FILE #81-94

TITLE HEADING: Site Plan Review - New
Commercial Building

LOCATION: 574 Northgate Drive

DEVELOPMENT PLANS FOR A COMMERCIAL BUILDING
FOR LOTS 26 AND 27, BLOCK 3
VENEGALE PARK
576 NORTHGATE DRIVE
GRAND JUNCTION, COLORADO

LANDSCAPE PLAN

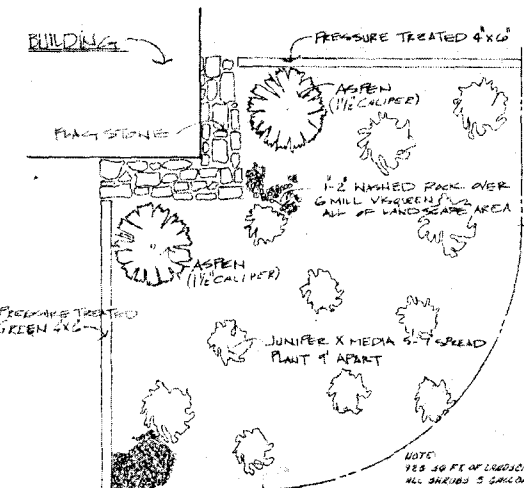
1. A note must be provided on the plans to indicate the necessary caliper of the aspen trees -- a minimum 1.5" caliper is required (measured one foot above ground level).
2. The applicant must provide an underground, pressurized irrigation system for the landscaped area. This must be noted on the plan.
3. The provided landscaping should extend to the pavement edge (the v-pan).
4. The material to be used to cover the area on either side of the proposed landscaped area must be indicated on the plans.

Our review of your covenants indicates that there is a minimum landscaping requirement for each street exposure in addition to a street tree planting requirement. If you plan on conforming with these requirements, you should indicate these items on your revised plans.

NOTE:
YES 30 FE OF LANDSCAPE
ALL SHRUBS 3 GALONS
PLANTING SHOULDS 97
NATURALITY TO COVER
25 %

ACCEPTED
ANY CHANGE OF SETBACKS MUST BE
APPROVED BY THE CITY PLANNING
DEPT. IT IS THE APPLICANT'S
RESPONSIBILITY TO PROPERLY
LOCATE AND IDENTIFY SETBACKS
AND PROPERTY LINES

KEY MAP
SCALE: 1\"/>

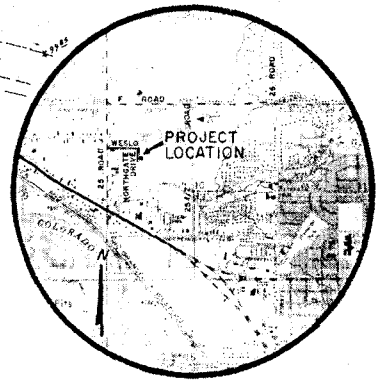
5. Based on the use of the graveled area as the primary circulation and parking area for the site, the area should be paved rather than graveled. In either case (1) directional signage must be provided to properly identify the entrance and exit lanes and (2) the parking stops must be reoriented to be consistent with the angled parking.

#1, #2, #7 not addressed. Also, a note must be provided indicating that the parking area will be paved. Otherwise, a time frame for paving will need to be developed with our office. We recommend that the area along the Northgate Road frontage between the entrance drive and the proposed landscaping not be paved. Also, since the circulation pattern is one way, signs and/or pavement markings will need to be provided to indicate the direction of site circulation.

NOTE:
PARKING LOT TO BE
PAVED BY MAY 30, 1975

Note:
Directional arrows to
be provided at
entrance and exit drives
